# **A Review of the 2014 Diavik Diamond Mine Wildlife Monitoring Report**

**Environmental Monitoring Advisory Board**

April 2015

**Figure I: A) Grizzly bear observations related to observation year. B) Days with bear visitations to East Island related to observation year. C) Days deterrent actions were utilized related to observation year (data from Tables 6 & 7 of the WMR 2014).**

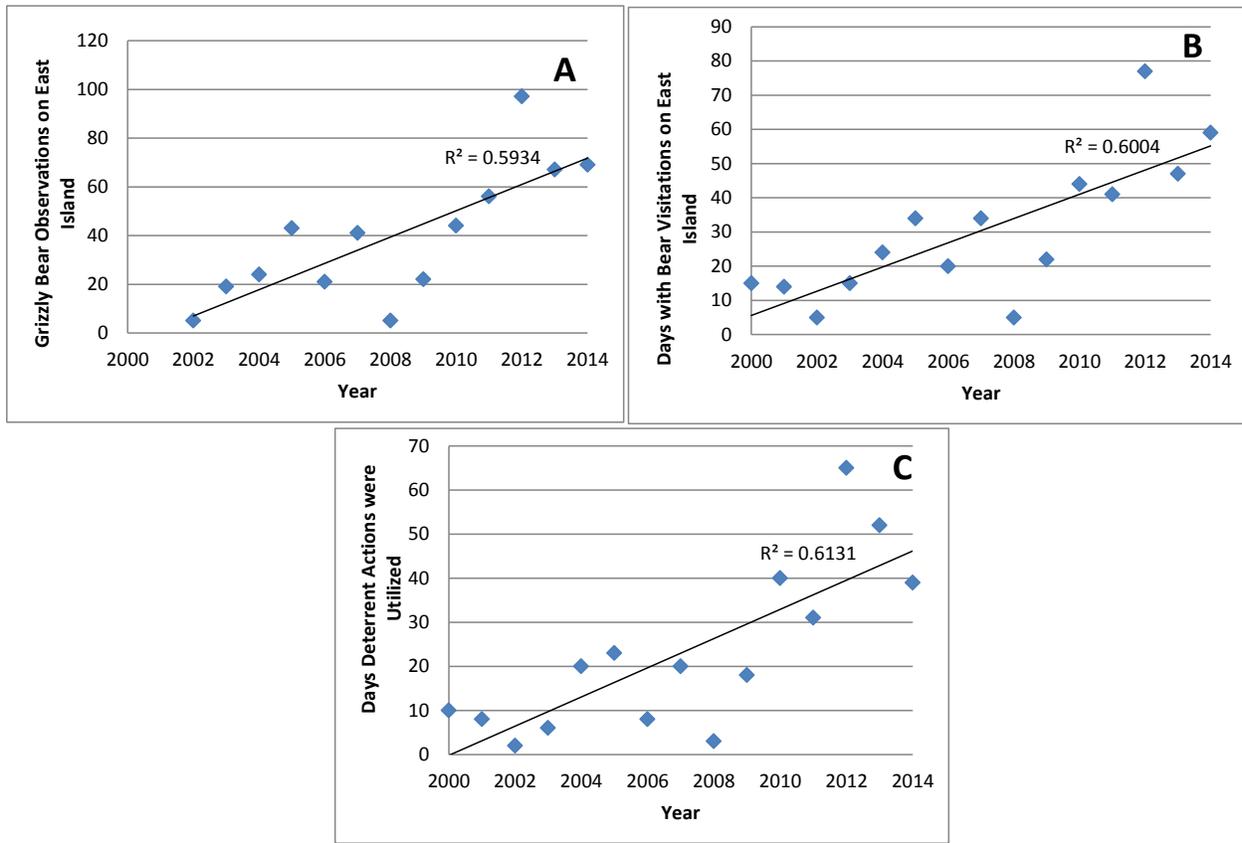
There is an increasing trend in the number of incidental grizzly bear observations over time (Figure 1A), the number of days with bear visitations to East Island over time (Figure 1B), and the number of days deterrent actions were utilized over time (Figure 1C). DDMI has indicated that the number of incidental observations of grizzly bears does not appear to be influenced by the number of people on site (Section 4.2.2.2). According to the numbers in Table 6, we agree. We reiterate our previous recommendations that, **given the increase in grizzly bear observations near the mine, DDMI should increase vigilance and future years of data collection should be used to evaluate whether the re-instated deterrent system (2013) is effective at reducing grizzly bear presence near the mine.**
